**AUTHORIZATION TO DISCHARGE UNDER THE
NATIONAL POLLUTANT DISCHARGE ELIMINATION SYSTEM**

Holtec Decommissioning International, LLC

**Pilgrim Nuclear Power Station
600 Rocky Hill Road
Plymouth, MA 02360**

Figure 1. Schematic of a Beaudrey WIP Screen. (Source: Beaudrey).

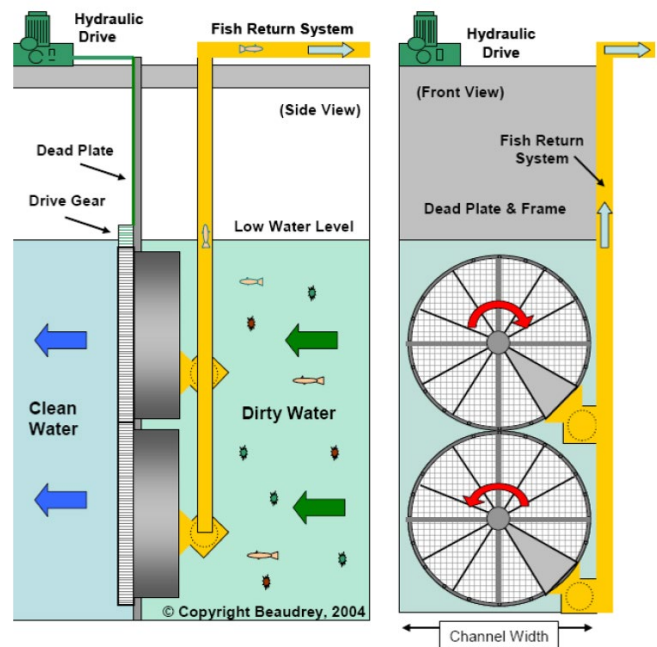
Finally, the commenter asserts that other available technologies to reduce impingement and entrainment at PNPS, such as the Beaudrey Water Intake Protection (WIP) screen or modified traveling screens, were not fully considered. WIP screens are designed with large disks divided into pie-shaped wedges that rotate around a center axle perpendicular to the intake flow (Figure 1). A stationary suction scoop mounted over one section of the disk vacuums debris and organisms as each wedge rotates under the scoop. A fish-friendly pump transports the organisms and debris to a return trough. *See* AR-717 at 2-7. This design eliminates "carryover" because the screen face, vacuum, and pump are all located on the same side of the screen. The screen material is designed to minimize impacts and organisms remain submerged for the duration of impingement and transport to the source water body. The commenter supports this technology, noting that the WIP screen "appears to achieve improved results to reduce mortality from impingement and entrainment and is capable of handling velocities of 0.5 fps." The comment states that the WIP screen's fish return system is gentler than the traveling screen and backwash system and that studies have observed benefits to species found at PNPS.²⁶

design, the WIP screen has a smaller dimension than the conventional traveling screen (see Figure 1). If the same number of screen bays are replaced with the WIP screens, the through-screen velocity will increase because the flow rate will be withdrawn through a smaller screen area. If PNPS were to install WIP screens without increasing the existing through-screen velocity (or to achieve, as the comment suggests, through screen velocities of no greater than 0.5 fps), the existing intake structure would have to be expanded to accommodate additional screens. Similarly, because the screen mesh affects the velocity, decreasing the mesh size of WIP screens to exclude early life stages of marine fish (e.g., less than 1 mm) would also necessitate additional screens to accommodate the required cooling water volume, which would require expansion of the existing intake structure. Expanding the intake structure would be more costly and would likely add a significant amount of time to the project as compared to simply installing new WIP screens in the existing bay. From a technical standpoint, while a WIP screen may be feasible for PNPS, it is not likely that it would meet the BTA requirements indicated in the comment without significant expansion of the CWIS. Moreover, the technology is not as effective as reducing impingement mortality and entrainment as the flow and intake velocity BTA requirements that can be achieved with the flow reductions associated with the shutdown.
